August 13, 2001

**SUBJECT: REVIEW OF CHEMISTRY ISSUES AND RELATED NRC STAFF CAPABILITY
FOR THE PROPOSED HIGH-LEVEL WASTE REPOSITORY AT YUCCA
MOUNTAIN**

**Report of the ACNW Working Group on Chemistry Issues
and Related NRC Staff Capability for the Proposed High-Level Waste
Repository at Yucca Mountain**

August 2001

Figure 1. Waste form degradation model in TSPA-SR.

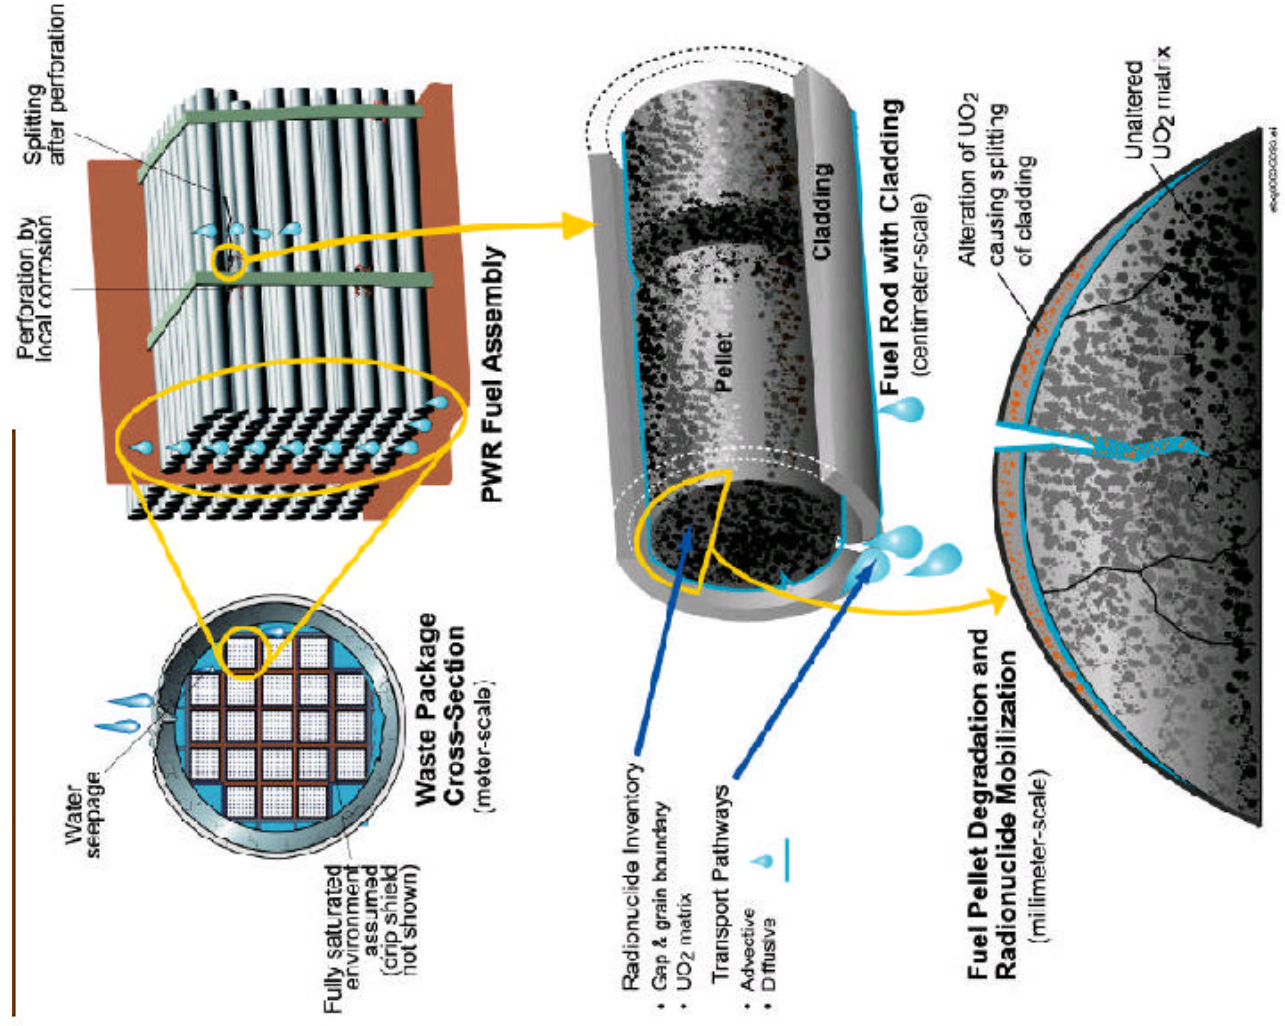
In DOE's TSPA-SR model, the calculated in-package pH^{vi} plays a fundamental role in determining the release of radionuclides from the EBS. The pH is used in calculating radionuclide solubility (e.g., of Np), spent fuel degradation rates, which congruently releases non-solubility-limited radionuclides (e.g., of Tc and I), HLW glass dissolution rates, and the stability of colloidal species (e.g., of Pu). The calculated pH thus serves as a "master variable" controlling the release of the most significant radionuclides in TSPA-SR.

The in-package chemistry model assumes all the void volume inside the waste package is filled with water (~4,500 liters) and that this water reacts with all available materials in the waste package (i.e., it behaves in a manner analogous to the way the same reactions would take place in a well-stirred bathtub). The approach taken in the model appears to be “conservative” because the radionuclide release model assumes much smaller amounts of water entering waste packages that intercept drips (between 15 and 0.15 liters per year). Moreover, most waste packages in the TSPA-SR model never have liquid water in them. DOE does claim that the approach is “conservative.” However, DOE apparently has not quantitatively evaluated the impact of smaller

To mobilize radionuclides from the EBS, the TSPA-SR model uses both diffusive releases (via moisture films in the EBS) and advective releases (via flowing water).²⁵ The TSPA-SR results show that diffusion dominates the overall radionuclide releases from the repository even in the absence of flowing water. The model of diffusive transport of radionuclides out of the waste packages and through the invert is decoupled from the amount of liquid water available in the waste package. The water chemistry model is developed for a fully saturated waste package and is used to provide concentrations for the diffusion model. A zero-concentration boundary condition is assumed outside the waste package and at the interface between the invert and the unsaturated zone rock. These assumptions imply significant water is present, whereas a diffusion only model implies extremely limited amounts of water are present. Thus, the TSPA-SR employs conflicting physical and chemical processes and conditions to model the source term release. While this appears to be a very “conservative” approach, it is not clearly discussed and leads to

confusion and uncertainty. What is more important, the use of this extreme “conservatism” in the model appears to be a significant contributor to relatively high dose values at long time frames and when waste packages are “neutralized”^x in DOE’s RSS analyses. This may lead to perceptions that early waste package failures would result in doses exceeding regulatory limits.
